## Avon Parks – Burnett Park and Winton Meadows Park Addendum 02

DATE: Friday, February 20, 2026

PROJECT NAME: **Burnette Park and Winton Meadows Park**

The extent of this addendum is as follows:

**GRADING PLAN**

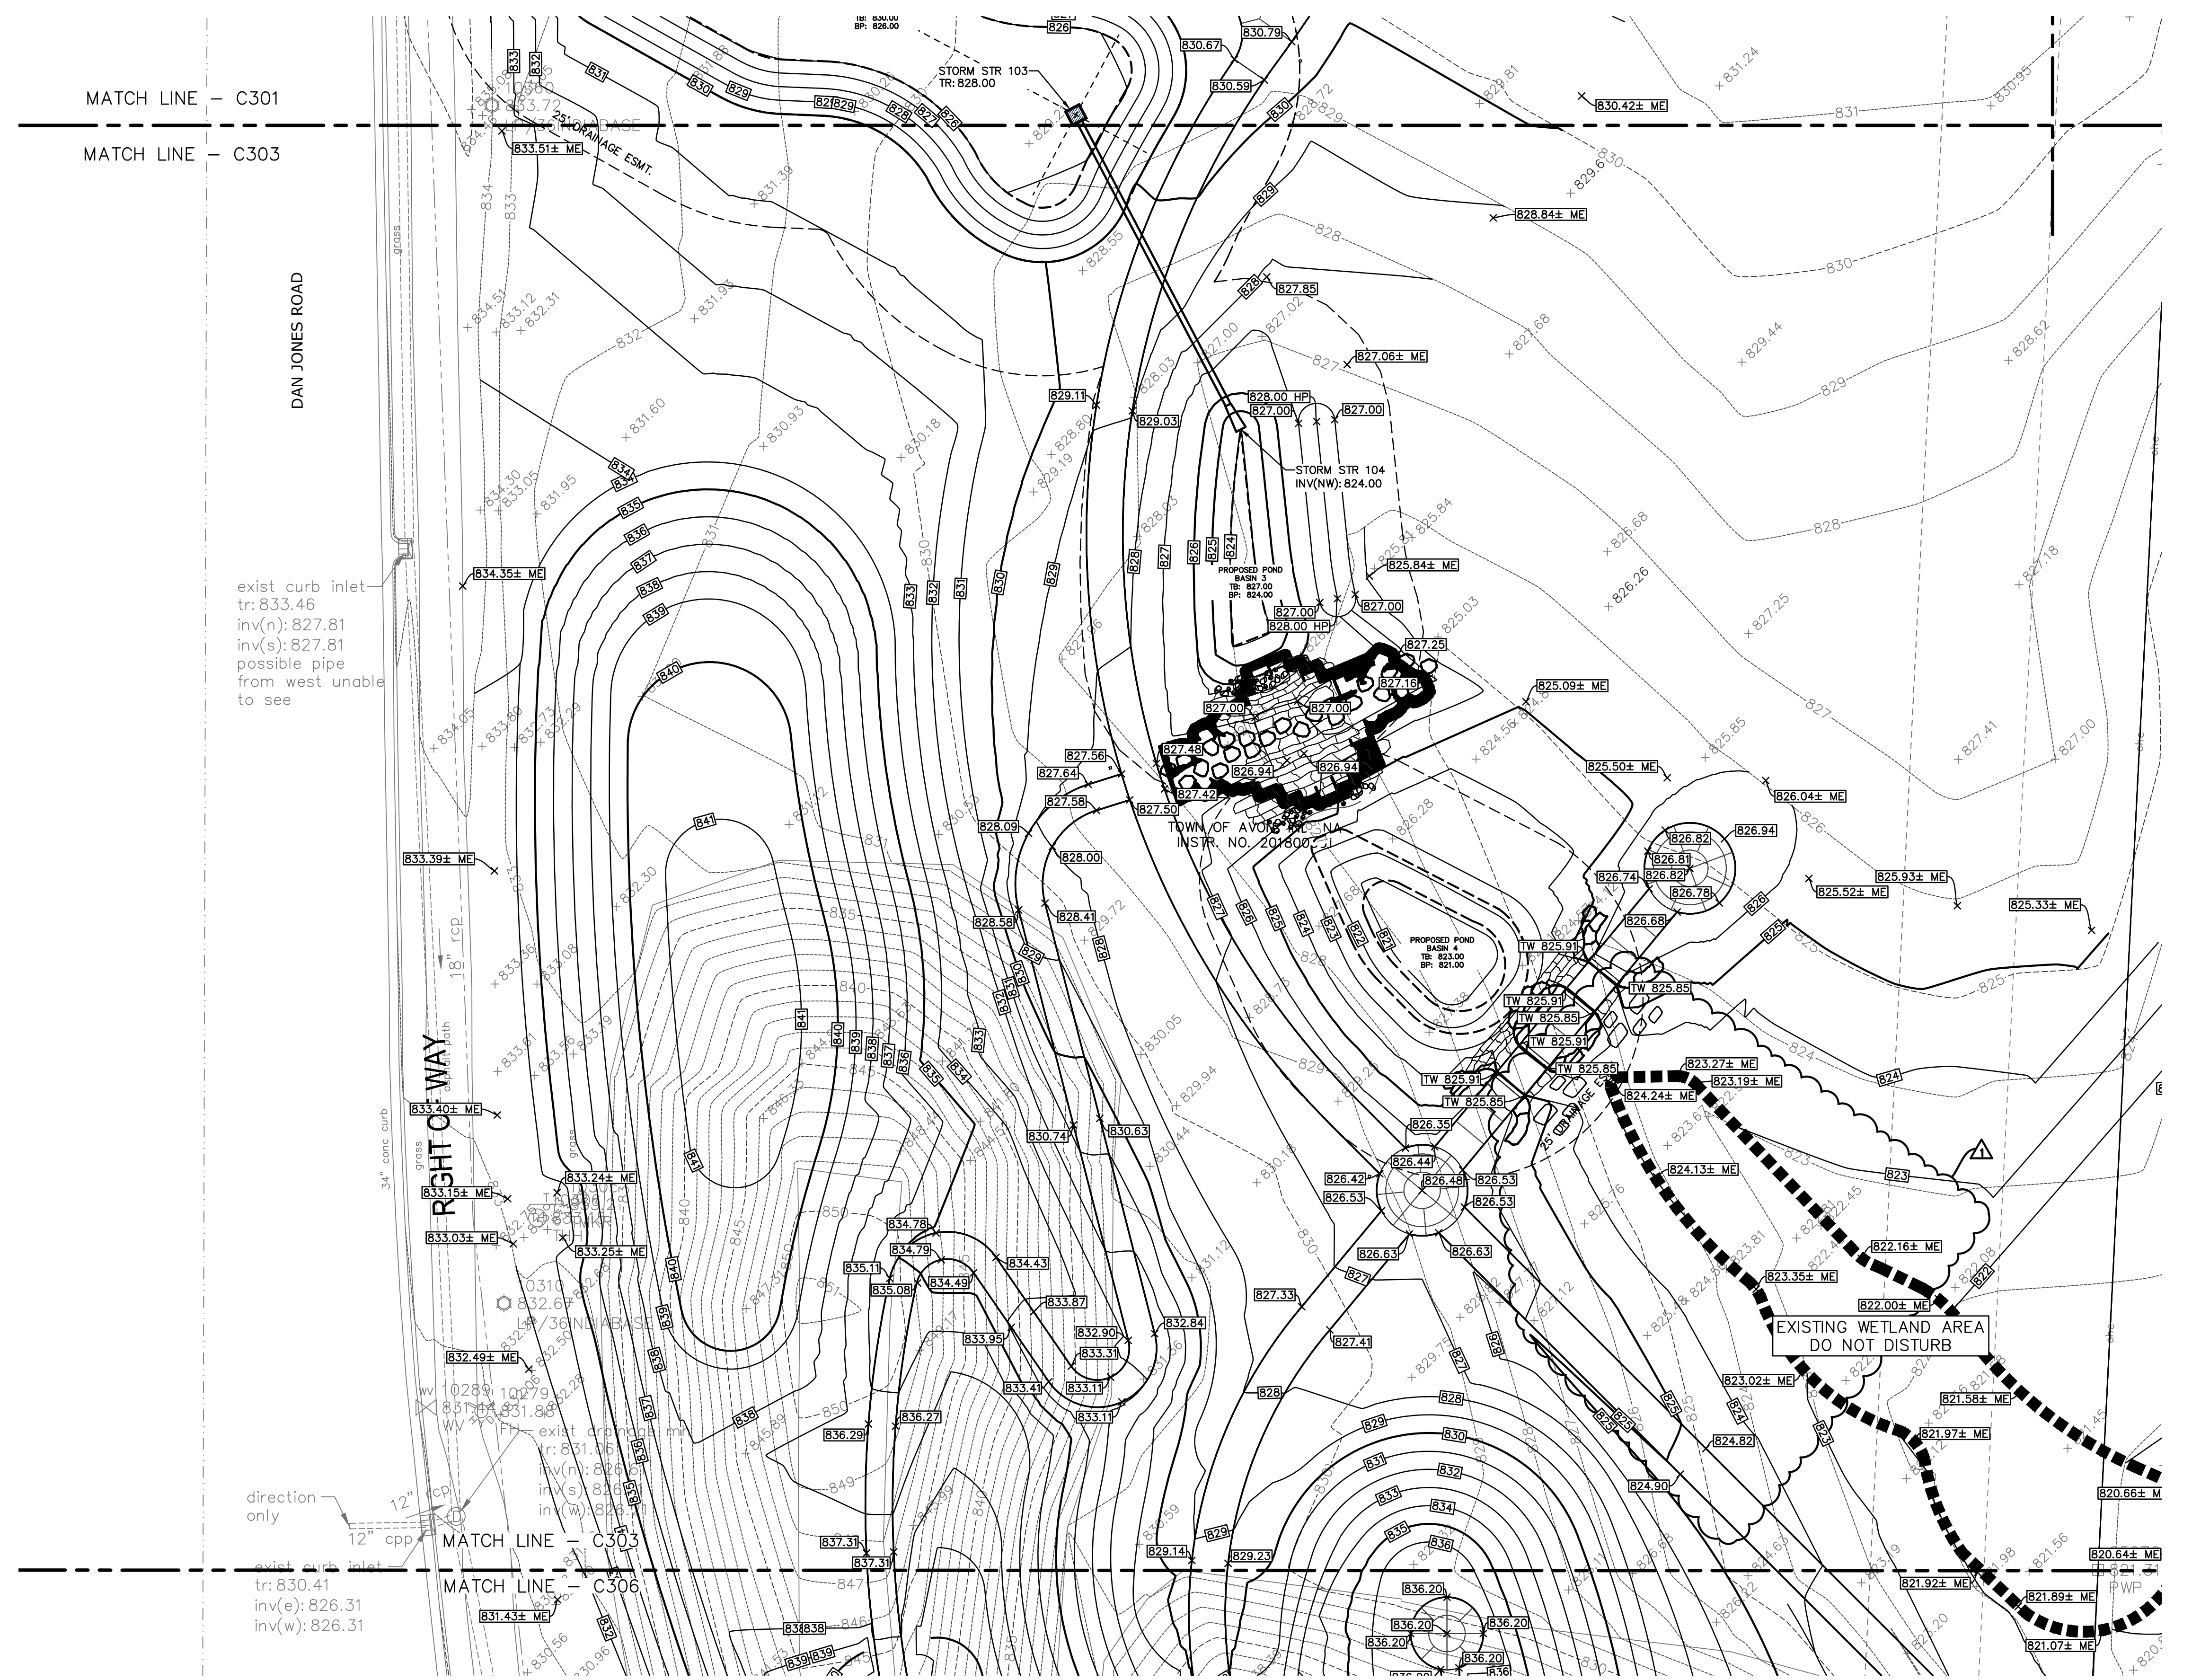
- a) Trail grades adjusted to less than 5% at bottom right of plan sheet. Overflow route adjusted from stone weir.

**STRUCTURE DATA TABLE**

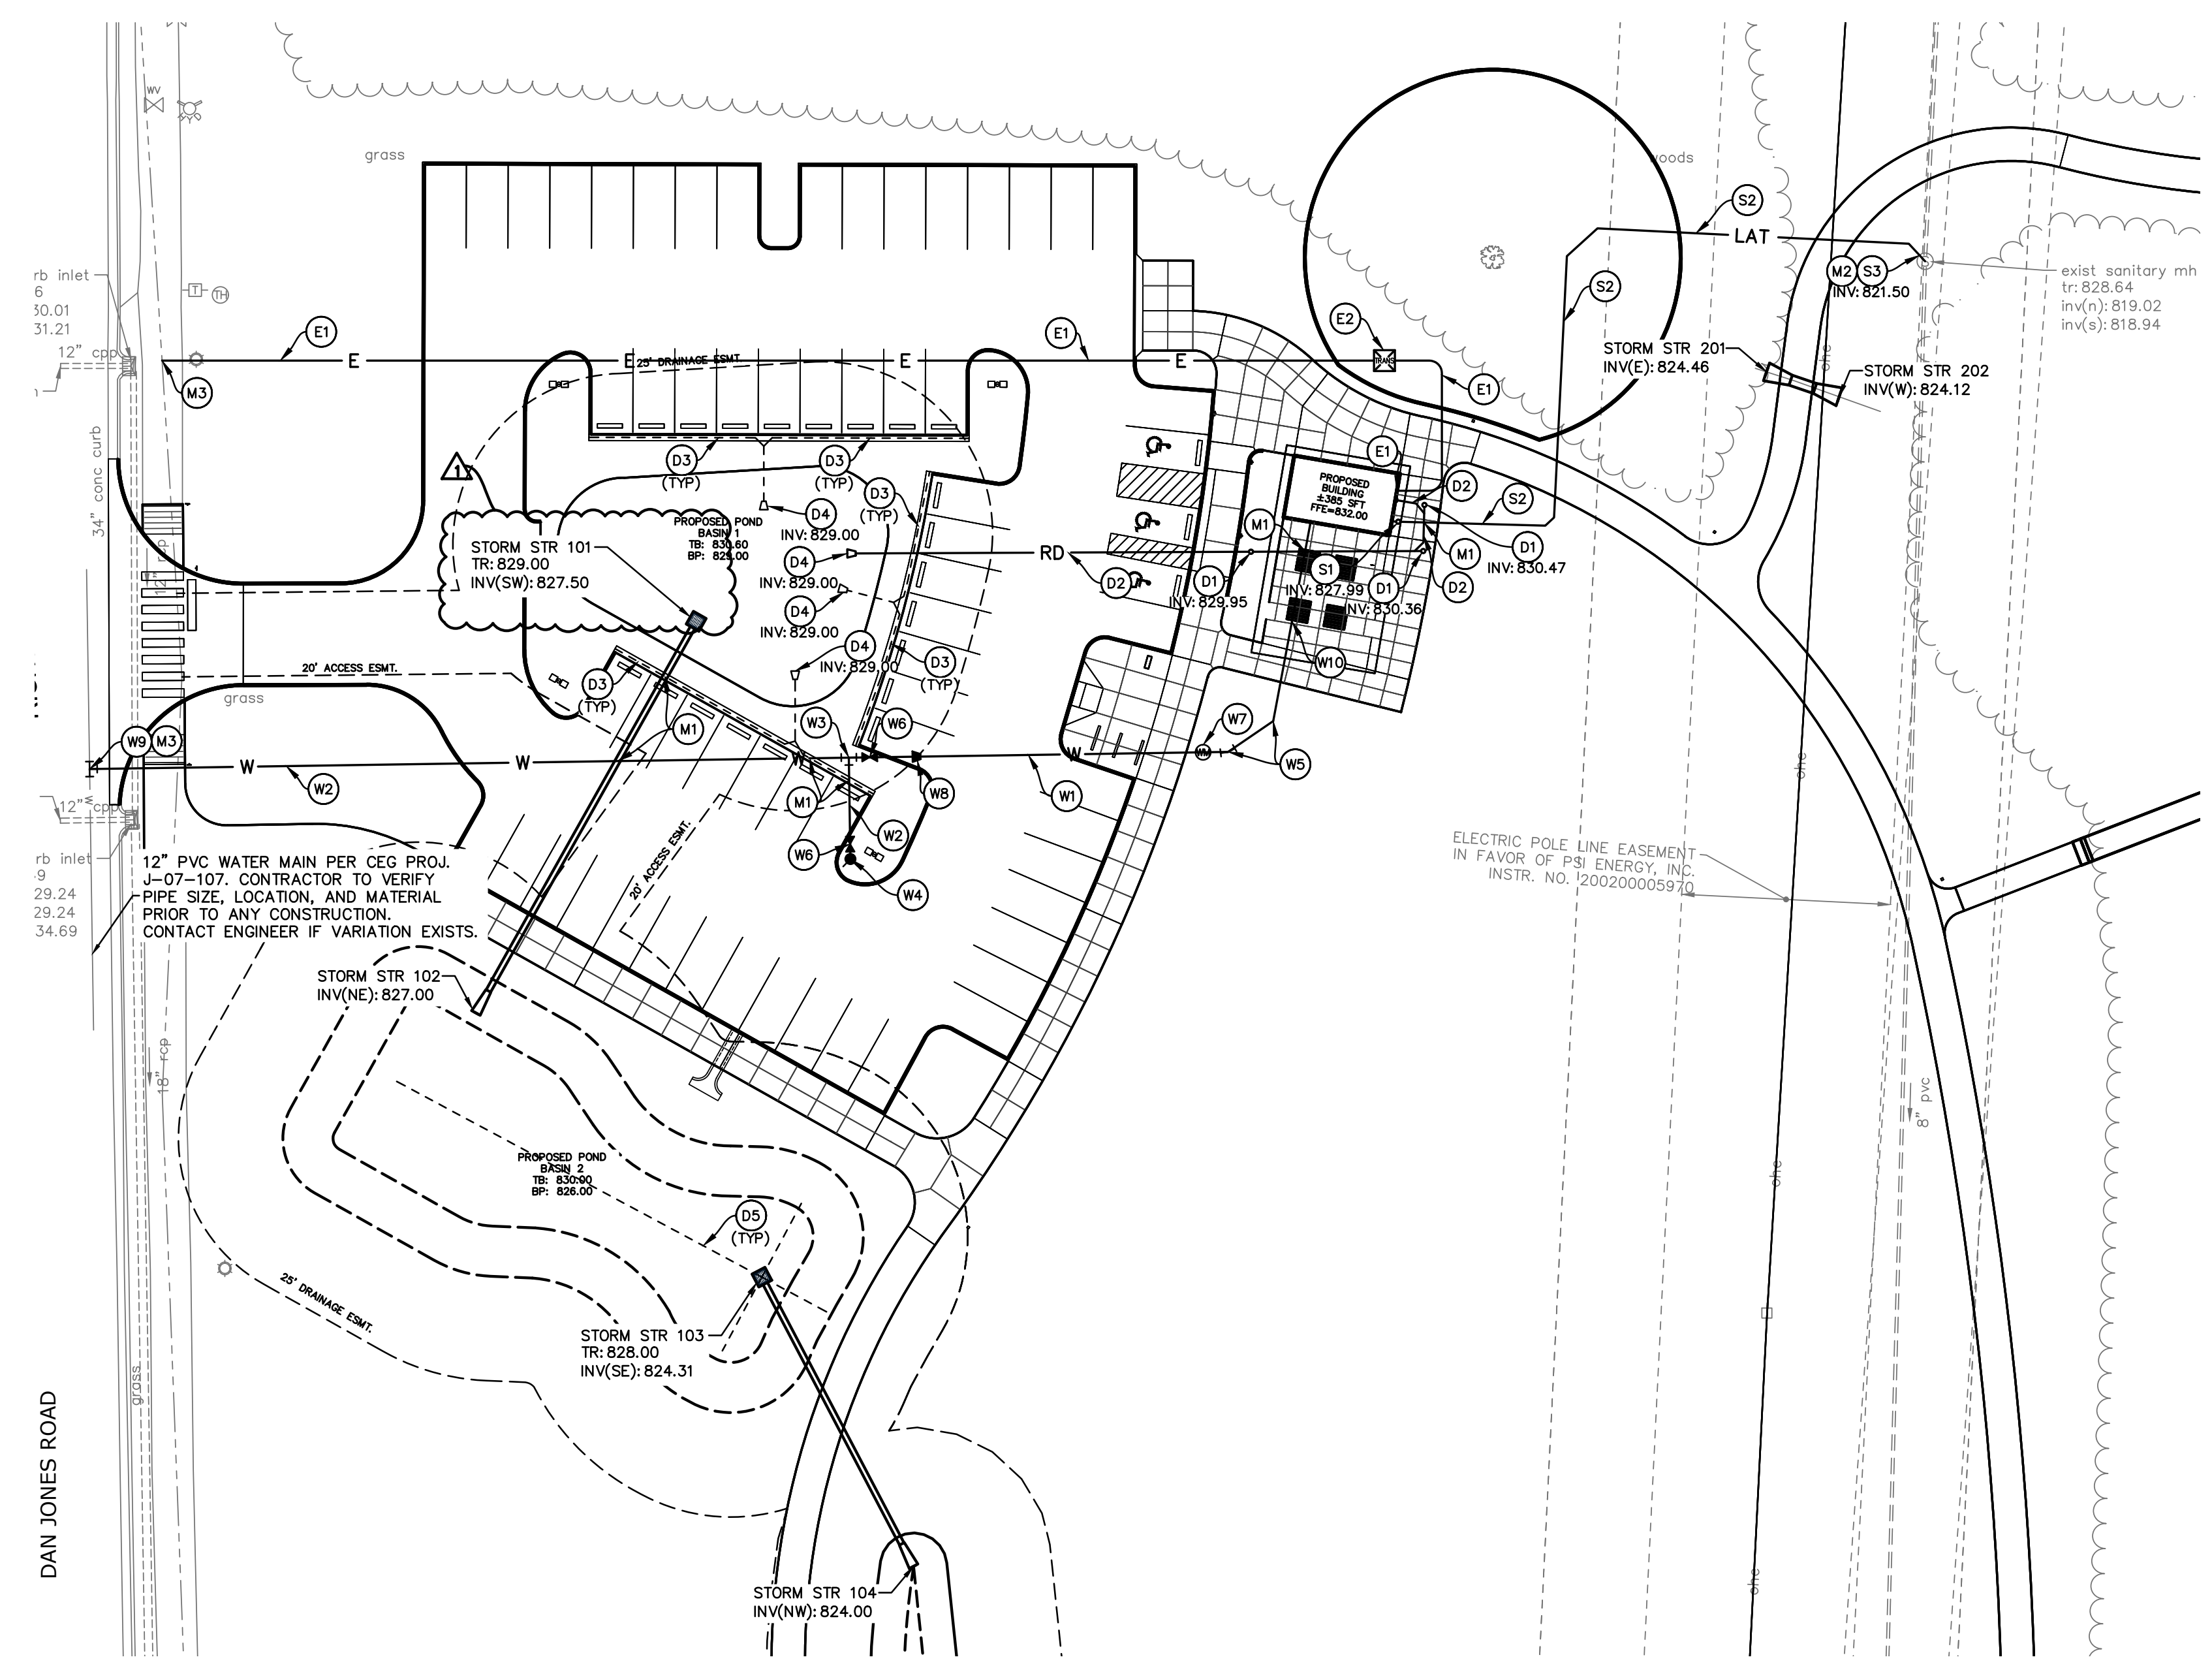
- a) STR 101 revised to inlet.
